SUBJECT: COMANCHE PEAK NUCLEAR POWER PLANT, UNITS 3 AND 4
DOCKET NUMBERS 52-034 AND 52-035
RESPONSES TO REQUESTS FOR ADDITIONAL INFORMATION NO. 3232 AND 3762

Response to Request for Additional Information No. 3232 (CP RAI #123)

RCOL2_09.0
4.05-3

Figure 9.4-201 UHS ESW Pump House Ventilation System Flow Diagram

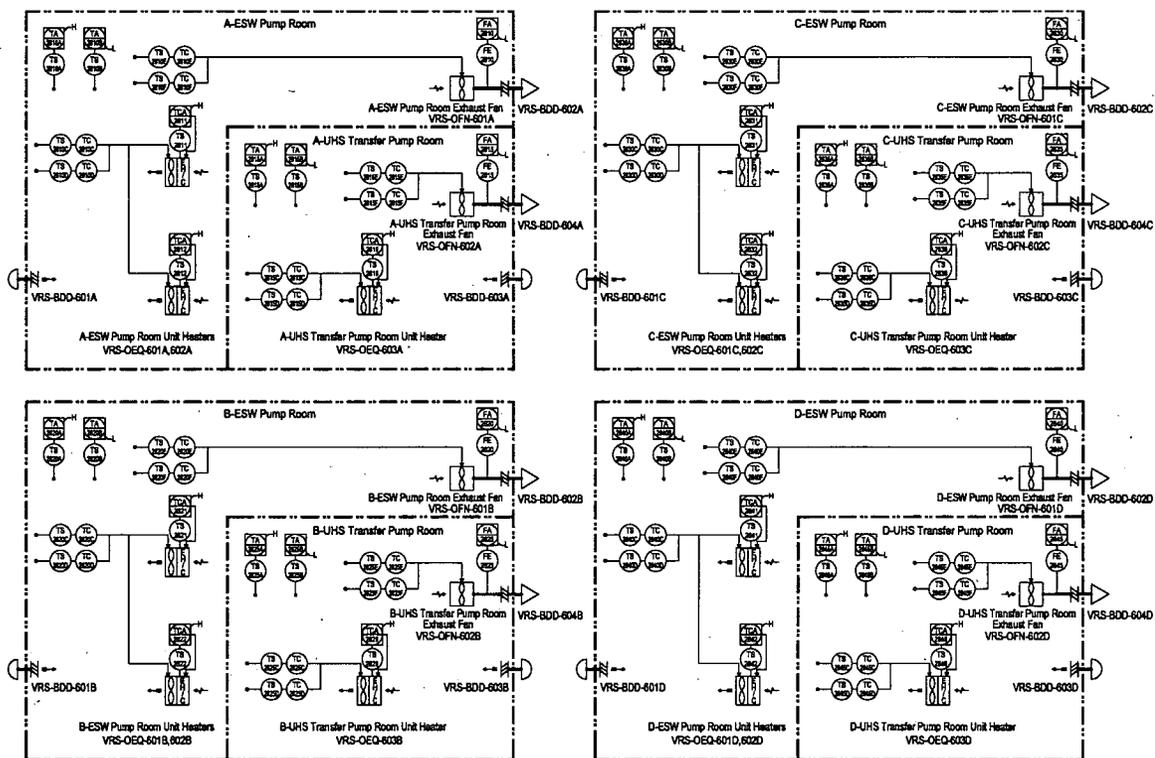
The NRC staff found that COL Figure 9.4-201 "UHS ESW Pump House Ventilation System Flow Diagram" of the applicant's FSAR does not indicate seismic classification of the components of the UHS ESW Pump House Ventilation System. Items 2.A and B of Section III "Review Procedures of SRP 9.4.5 indicates that the piping and instrumentation diagrams (P&IDs) should designate the seismic classifications of components and demarcate division between classifications.

Please provide P&IDs that designate the seismic classifications of components and demarcate division between classifications

In addition, the NRC staff found that it appears from review of Figure 9.4-201 that heating ventilation and air conditioning (HVAC) duct work exists on both sides of the back draft dampers of the air outlets and on the upstream side of the back draft dampers of the air intakes of each room's ventilation system. The staff found that Table 3.2-201 "Classification of Site-Specific Mechanical and Fluid Systems, Components, and Equipment" does not list "ducts" or ducting as a system component for UHS ESW Pump House Ventilation System. Please explain why Table 3.2-201 does not list ducts or ducting as a system component.

1. The UHS ESW Pump House Ventilation System contains no ductwork. The damper is mounted in the seismic category I wall opening and the fan is mounted on the seismic category I wall of each independent UHS ESW pump house. All ventilation system equipment and components are classified as equipment class 3, seismic category I. There is no seismic classification break needed. A note has been added to FSAR Figure 9.4-201 stating that all UHS ESW Pump House Ventilation System equipment and components (fans, heaters, dampers) are seismic category I.

2. The UHS ESW Pump House Ventilation System contains no ductwork, as indicated by revised FSAR Figure 9.4-201.
3. The UHS ESW Pump Houses each contain a wet-pipe sprinkler system, hose station and smoke detection system. These fire protection components are classified as non-safety-related. With the exception of standpipes supplying manual hose stations, these fire protection components are seismically supported such that their failure during a design basis seismic event will not damage any of the safety-related equipment in the areas. As discussed in DCD Subsection 9.5.1.2.4, the standpipe systems supplying hose stations are designed to remain functional under safe shutdown earthquake loadings for manual fire suppression in areas containing equipment required for safe-shutdown.

Revised FSAR Figure 9.4-201 is attached to show that the exhaust fans are wall mounted and the backdraft dampers are located in the wall openings. No duct work is installed in the system. A note has been added stating that ventilation system equipment and components (fans, heaters, dampers) are seismic category I.

1. All fans, dampers and heaters in this sheet are designated in accordance with Seismic Category I.
2. Backdraft dampers are mounted in the wall opening.
3. No system ductwork is installed.
4. Exhaust fans are wall-mounted.

Figure 9.2.5-201 Ultimate Heat Sink System Piping and Instrumentation Diagram (Sheet 1 of 2)

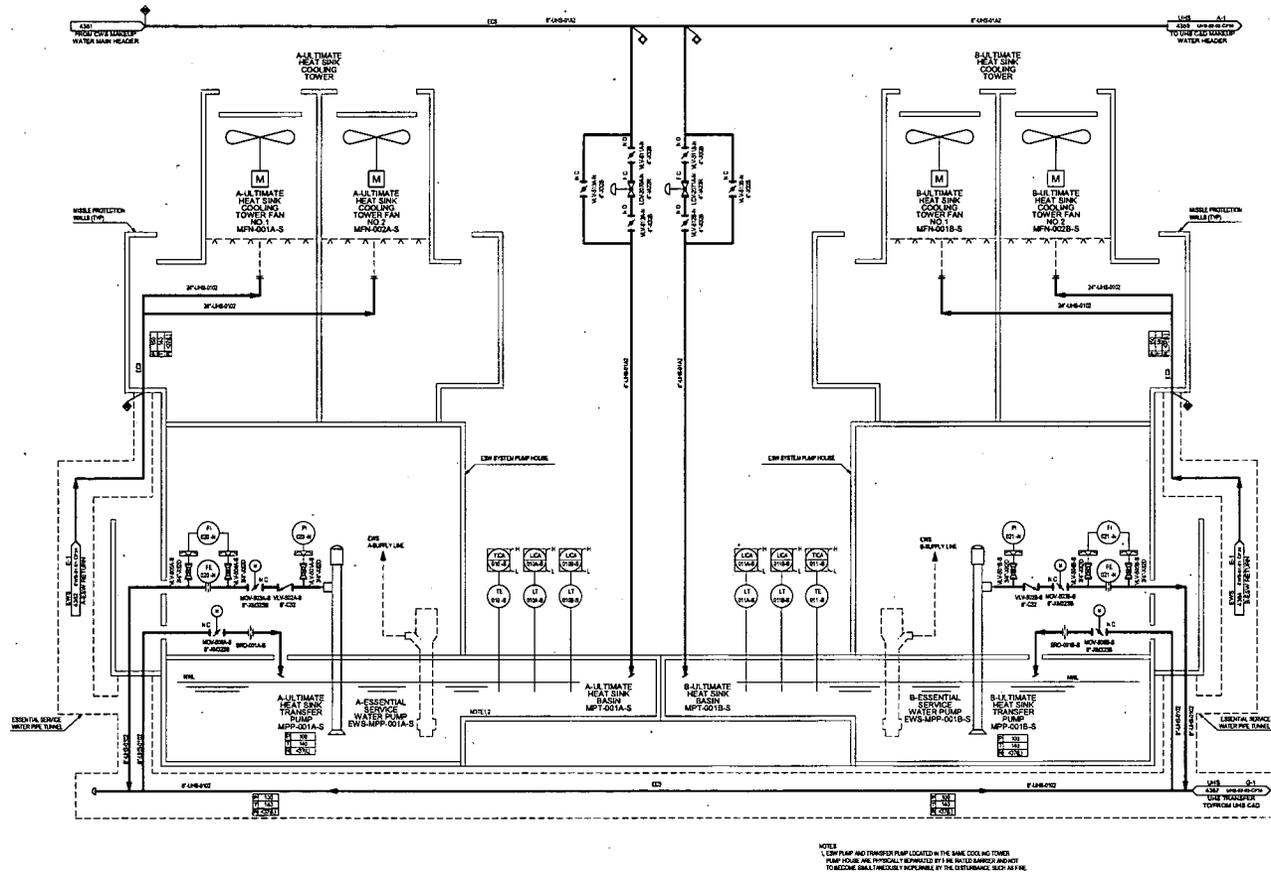
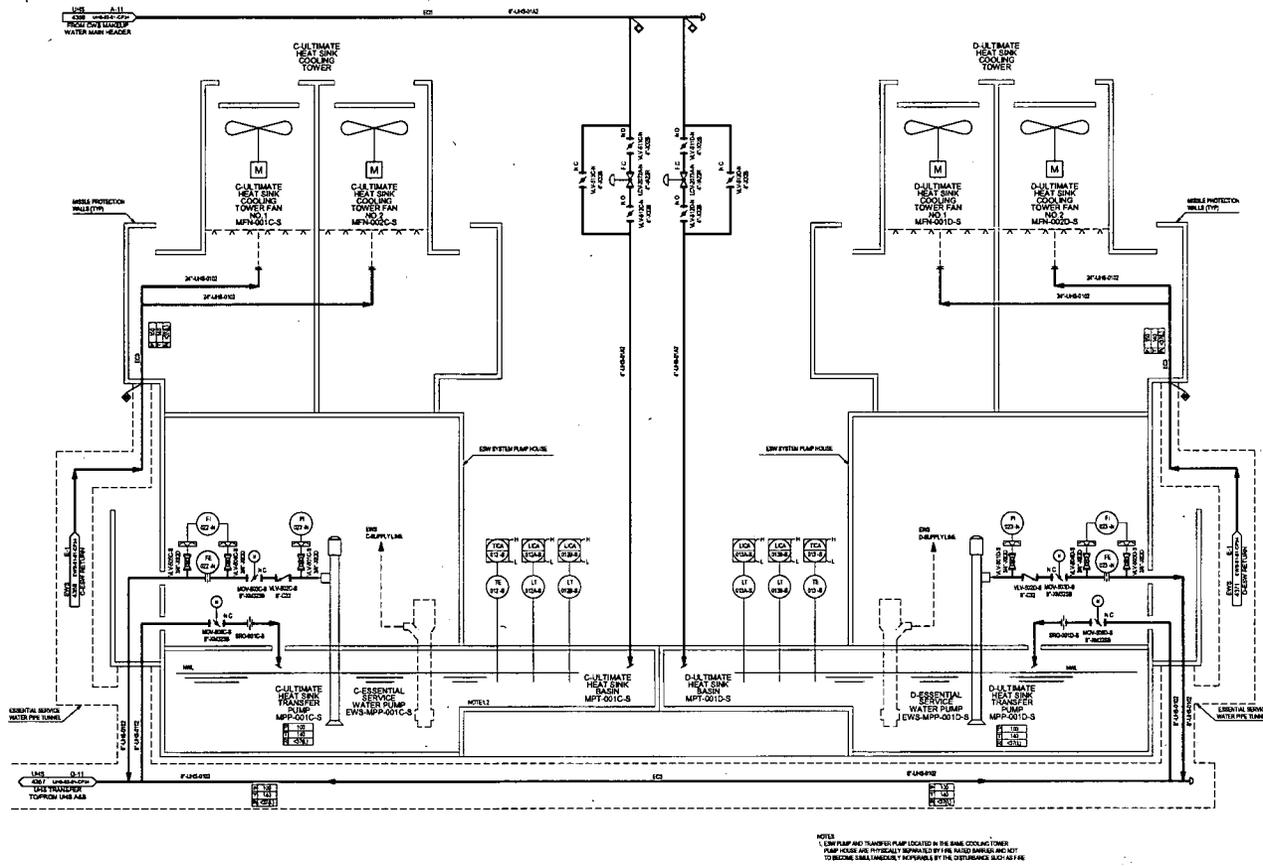
- FSAR Figures 1.2-206, Section E1-E1, and 1.2-210, Section D2-D2, show the transfer pump discharge pipe going into different essential service water (ESW) tunnel compartments; whereas, the description in FSAR Section 9.2.5 and Figure 9.2.5-201 indicate that there is only one common transfer pump discharge/transfer pipe such that only one of the compartments would be used.

- As stated in the response to the first bullet item of Question 9.02.05-1 of this RAI, FSAR Figures 9.2.1-1R and 9.2.5-201 include information to identify local instrumentation and instrumentation that provides input to the MCR (via PSMS or PCMS). The attached COLA Part 10, Appendix A.1 Tables A.1-2 and A.1-3, as revised per response to RAI 3293 (CP RAI 81), Questions 14.03.07-5 and 14.03.07-7, respectively show: (1) the site-specific UHS and ESWS equipment characteristics (including remotely operated valves and active safety functions of equipment); and (2) alarms, displays and controls in the MCR and remote shutdown console (RSC).

- A common discharge header is provided for all four UHS transfer pumps. A discharge pipe from each transfer pump penetrates its basin wall and is connected to the common header. The discharge header running the entire length of the cooling towers is located in the ESW pipe tunnels adjacent to the UHS basins and penetrates the tunnel wall. FSAR figure 9.2.5-201 is a piping and instrumentation diagram and not all structural details are shown on this drawing. FSAR Subsection 9.2.5 is revised to clarify the description.
